Addendum 40 – UN Regulation No. 41

Revision 2 - Amendment 9

Supplement 9 to the 04 series of amendments – Date of entry into force: 30 September 2021

Uniform provisions concerning the approval of motor cycles with regard to noise

"Figure 1
 Test track layout with dimensions in meters

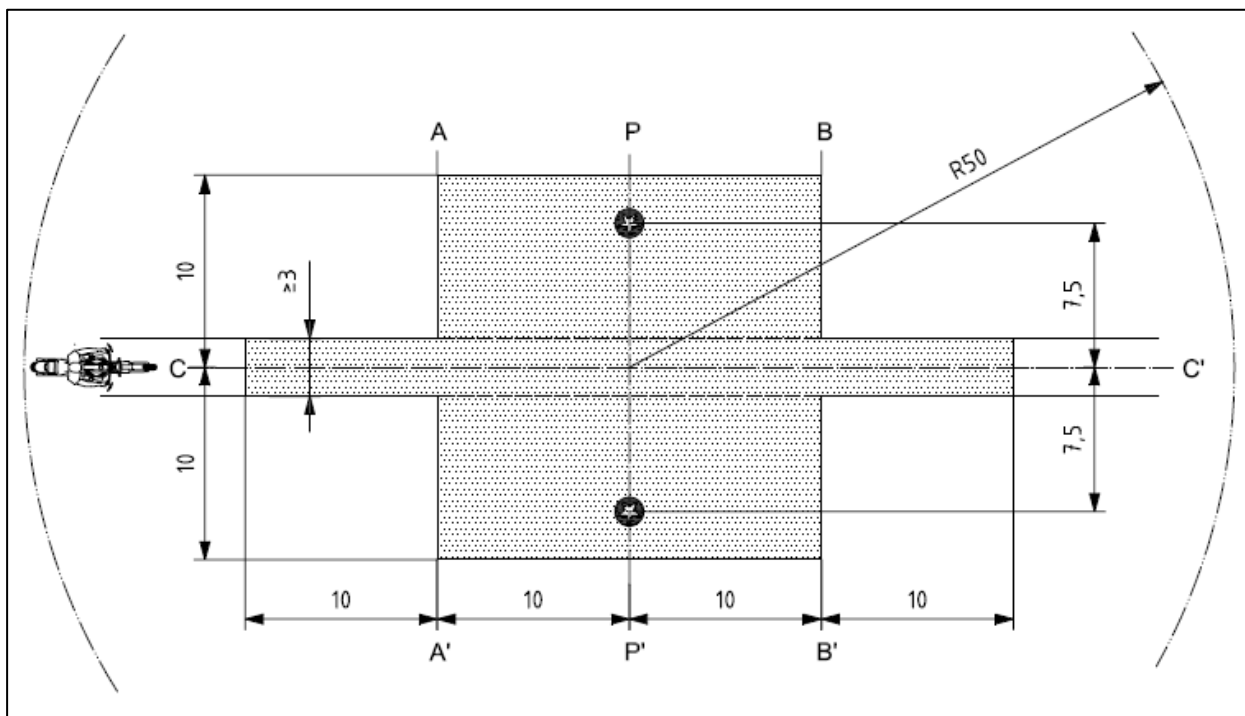
Figure 1, amend to read:
